RE: COVID-19 Recovery (Fast-Track Consenting Act 2020 – Scott Road Development – Comments Sought

The application is made by Aedifice Development Limited and is located at 4 Scott Road, Hobsonville (Lot 1 DP 71841).

Enclosure A: Summary of Auckland Council collective response – 4 Scott Road

1959 aerals

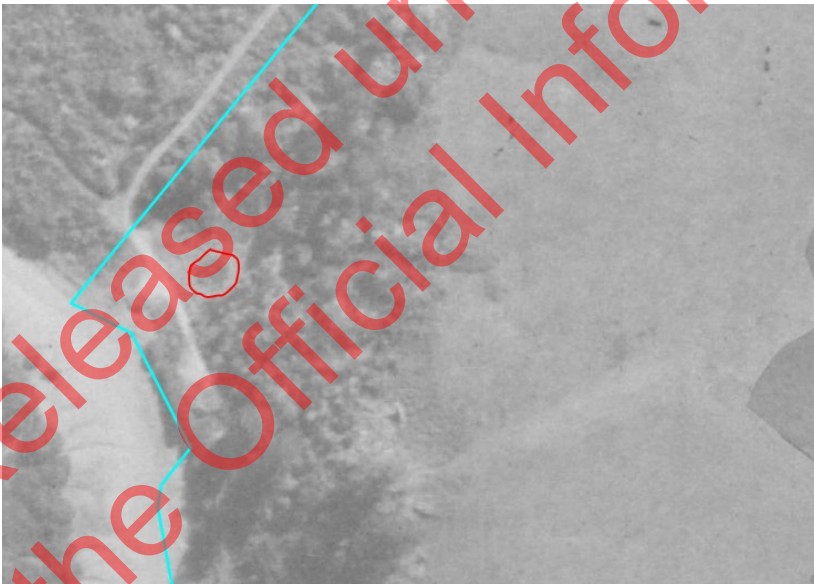
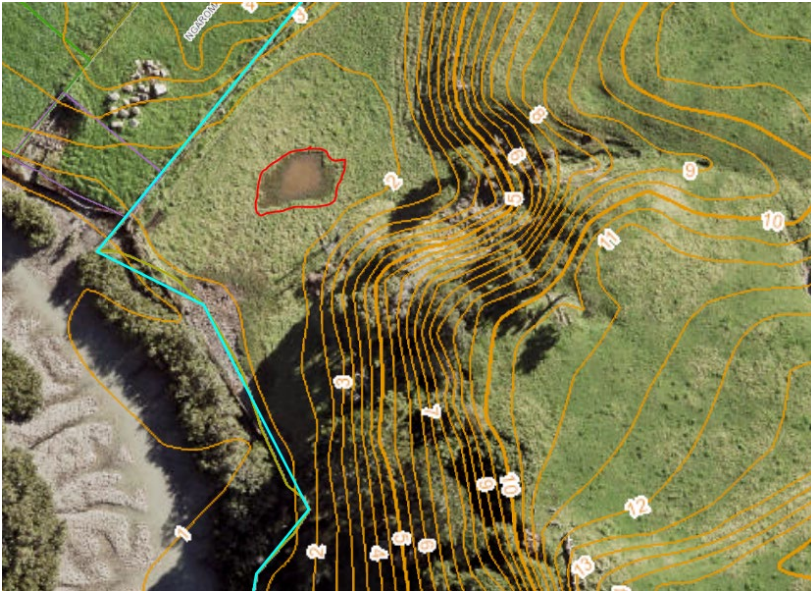
There is an area of water visible on GIS aerals, located at a low point where ground and surface water would naturally flow to. The extent of water seems to vary seasonally on historic aerals. This water body could be considered a natural wetland; however, needs further investigation. The area is visible in historic aerals from 1959 (see below). This area is not identified on the applicant's plans as a wetland. This potential wetland is located within the proposed earthworks area and if it met the criteria of a natural wetland, would mean the earthworks are a prohibited activity under regulation 53 of the NESFW (2020). The loss of a natural wetland is considered a significant adverse effect and would be inconsistent with the AUP:OP and NPSFM (2020). Note that this area was highlighted as a potential wetland to the applicant in a pre-application meeting held on 19 April 2021 and no further investigation or comment has been received.

Based on the uncertainty, and the implications being a potential prohibited activity that would otherwise result in significant adverse effects, this area is identified as a red flag for the application.

Map 1: Potential natural wetland area in SW corner of site.

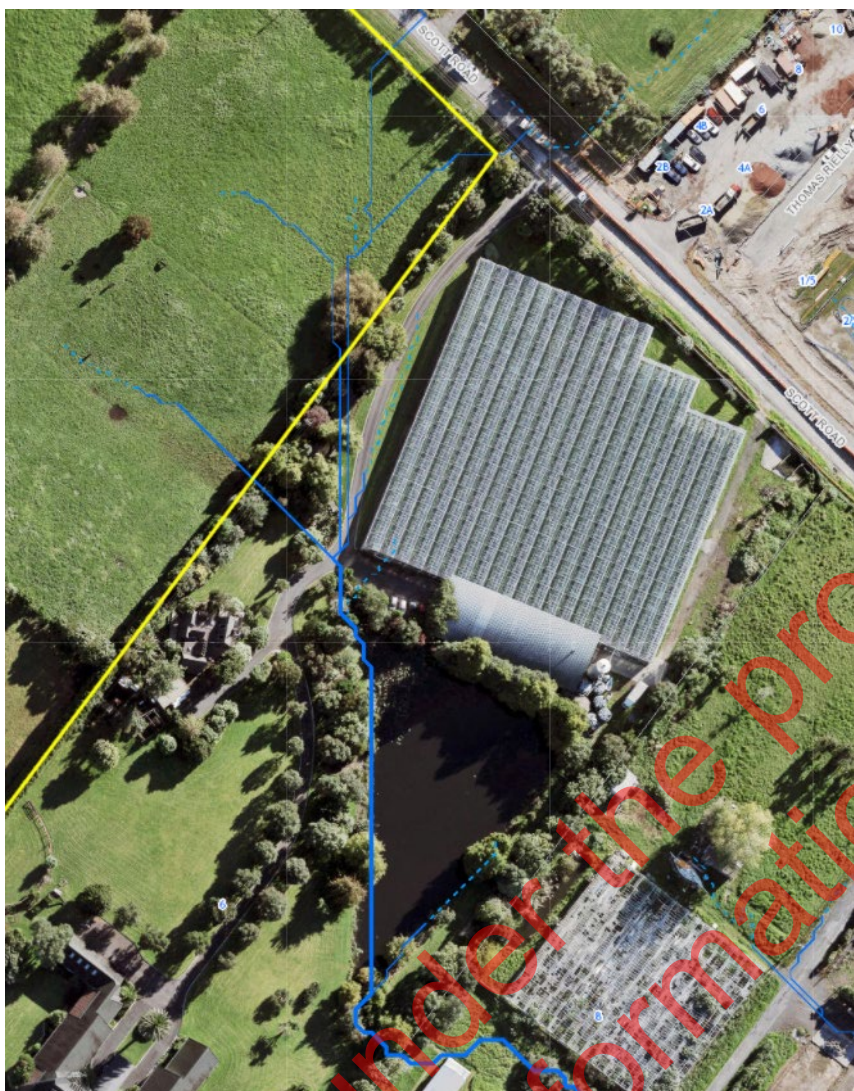
However, there are two areas that are partially or fully outside of the esplanade reserve that are not considered natural wetlands in the Ecology Memo. Map 1 (below) shows the SW corner of the site which has ponding and overland flows running into the lowland area. From the historic aerial imagery and the topography, it looks like this area is potentially a natural wetland which has previously been cleared and grazed. The proposed scheme plan indicates the northern arm of this area would be reclaimed. Map 2 shows another potential wetland on the eastern boundary of the site. This area has overland flow paths leading into a lowland area, ponding water, and vegetation typically found in wetlands. Both of these areas will need to be assessed and delineated in order to assess the potential adverse environmental effects of the proposed works. If these areas are classified as wetlands, the natural hydrology would also need to be protected.

Figure 1- Mark up of layout plan

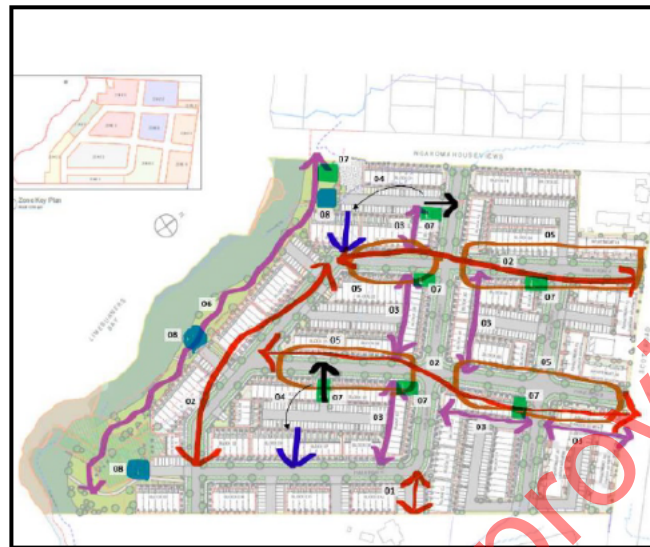
Roads A and B could be redefined to avoid encouraging speeding by avoiding a long/straight stretch of road and introducing bends/curves to help reduce speeds (see red arrows in Figure 1 below illustrating a revised alignment to slow traffic). Indented parking spaces should be provided throughout the development.

A walking and cycling connection should be included where Road E terminates at the south end through the JOAL, to provide active modes connectivity. The rear pedestrian access to lots should be redesigned so that they allow for a 2.5m wide minimum connection across proposed blocks and between proposed streets (please see purple arrows in Figure 1 below).
